Nomad **ALERT SERVICE BULLETIN**

**TRANSMITTAL LETTER
FOR
SERVICE BULLETIN ANMD-71-8**

**POWER PLANT — ELECTRICAL HARNESS — STARTER CIRCUIT
FIREWALL STUD — INSPECTION AND REPLACEMENT (MOD N789)**

ANMD-71-8

Figure 1 Starter Cables and Stud Assembly

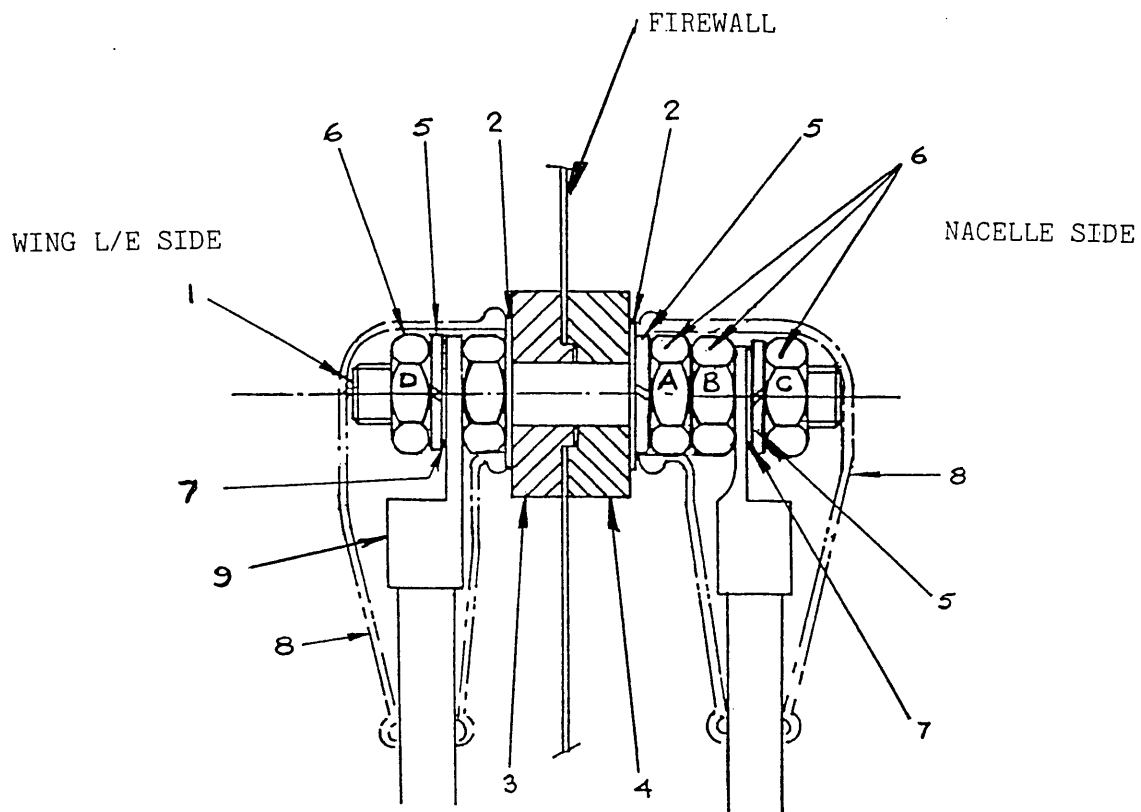
Incorporation of Mod N789. The existing steel studs, PN 1/N-81-424, are replaced with copper studs, PN 1/N-81-925. The attaching hardware and cable lugs are also replaced.

All item numbers refer to Figure 1.

- 1 Onto the longer end of the stud (1) place special washer (2) and insulating washer (3).
- 2 Insert stud through firewall from the wing leading edge side.
- 3 Place insulating washer (4), special washer (2), spring washer (5) and nut (6A) onto stud.

Before tightening nut (6A) apply Loctite 242 Nutlock to the threads on the stud. Preparation, application and curing of the Loctite should be in accordance the manufactures instructions.

TAKE CARE NOT TO CRUSH THE INSULATING WASHERS WHEN TIGHTENING NUTS (6A) AND (6B).

- 4 Torque tighten nut (6A) to 20 in lb.
- 5 Assemble locknut (6B) and torque tighten against nut (6A) to 80 in lb.
- 6 Connect cables K1B2 and K2C2 to respective studs, washer (7), spring washer (5) and nut (6C).
- 7 Torque tighten nut (6C) to 60 lb in and replace protective cover (8).

- 8 On the inboard side of the firewall connect cables K1A2 and K2B2 to respective studs, washer (7), spring washer (5) and nut (6D).
- 9 Torque tighten nut (6D) to 60 lb in and replace protective cover (8).
- (g) Reconnect battery and at the next engine start check Starter operation in accordance with 'Starting Procedure', Section 3 of the relevant Flight Manual.
